# Maximum Tx Power Limits for 25GBASE-ER

E M Kimber – Semtech

kimber\_3cc\_01a\_1116.pdf

# Modelling ER 40km link

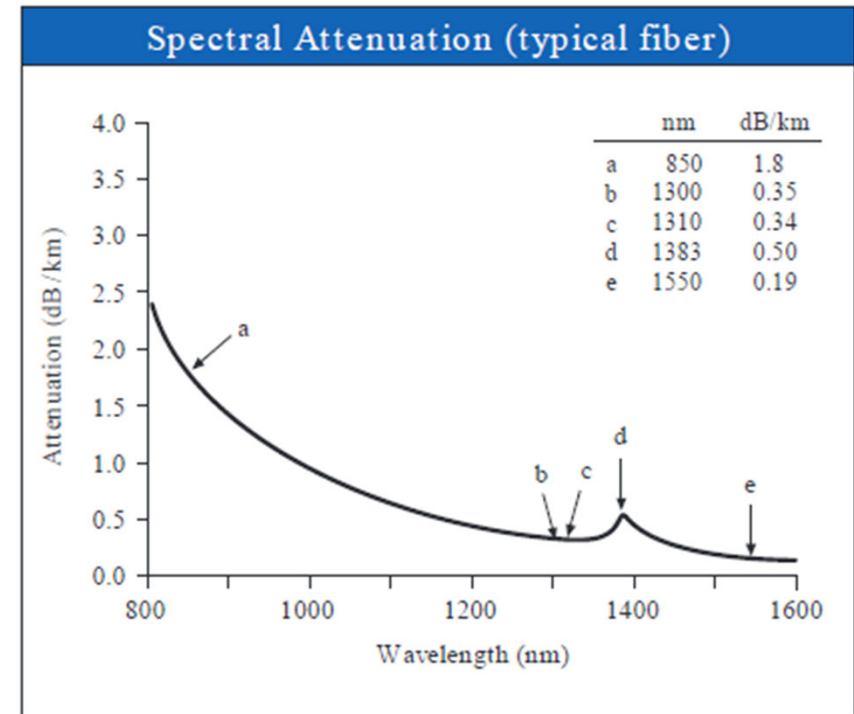
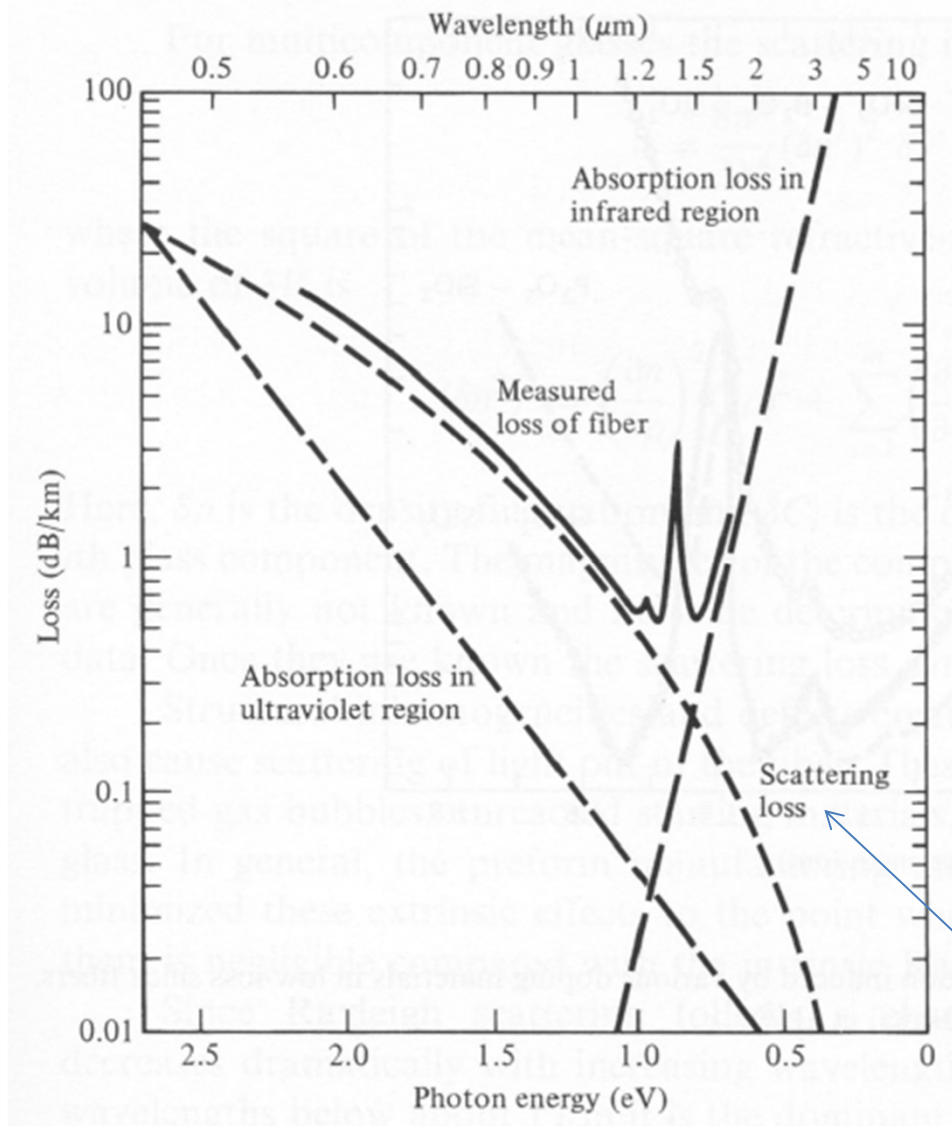
- Worst case is low loss fibre – extends  $L_{\text{eff}}$ 
  - Assume 0.25dB/km for lowest loss fibre
- NRZ modulation

$P_{\text{thres}} < +6\text{dBm}$  (max transmitter power) – Recommend keeping  $>1\text{dB}$  from  $P_{\text{thres}}$

- To avoid potential SBS and using SBS suppression techniques recommend keeping maximum transmitter power about 1dB lower than lowest  $P_{\text{thres}}$
- Recommend changing maximum transmitter power to +5dBm
